SUBJECT: RECALL R10RW POWER CABLE LUG ORIENTATION

R10RW

Incorrect Power Cable Lug Orientation

Models Affected: 2004 through 2009 Vision

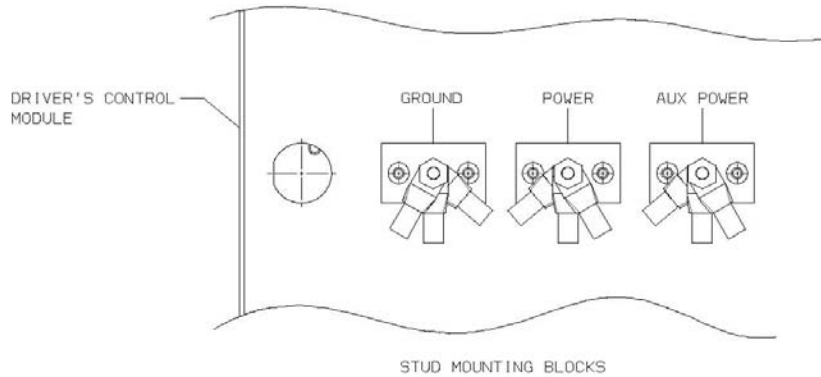
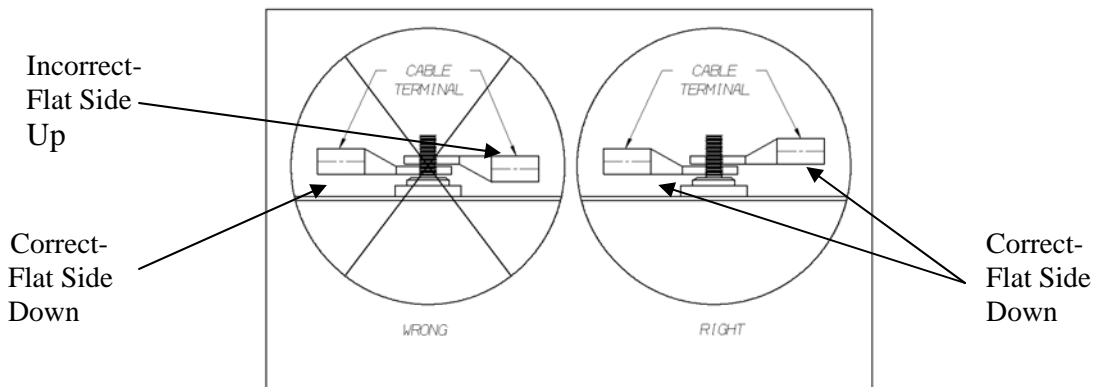
1. Park the vehicle on a level surface, apply parking brake, turn engine off, remove ignition key and chock wheels.
2. Disconnect batteries. *Always remove negative cables first.*
3. Open engine hood and locate the Chassis Power Stud(s) on the driver's side of the **Driver's Control Module (DCM)**. Depending on the type of engine installed and options on the vehicle (air conditioning and/or lift), there could be one or two power studs next to the Ground Stud. See the following diagrams.

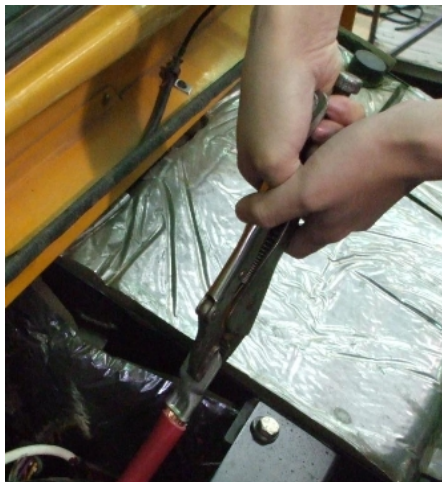
4. Inspect the electrical cable connections at the Power Stud and Aux Power Stud, if installed. See the diagram below to determine if the cables were installed correctly. ALL terminal lugs on each power stud should be oriented such that the barrel of the lug is further away from the mounting surface of the isolated stud. The flat side of terminal end (lug) must be down.

5. If the cables were installed incorrectly, remove the nut securing the cables. Then remove the cables and reinstall correctly per the diagram above. Make sure the terminal lugs are fanned out on the stud as opposed to directly on top of each other. Vice-grip pliers are recommended when turning incorrectly installed cable terminal lug to the correct orientation of flat side down.

Caution: Do not grasp cable on insulation

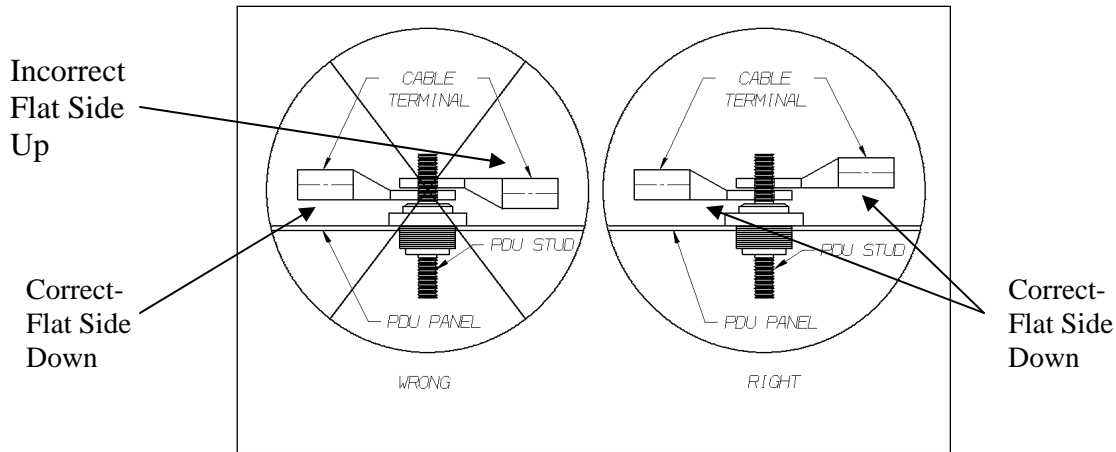
10. Remove the two red protective covers and inspect the electrical cable connections at the Power Studs.

ALL terminal lugs on each power stud should be oriented such that the barrel of the lug is further away from the mounting surface of the isolated stud. The flat side must be down.

If cables **are not** installed correctly, follow steps 11 through 15.
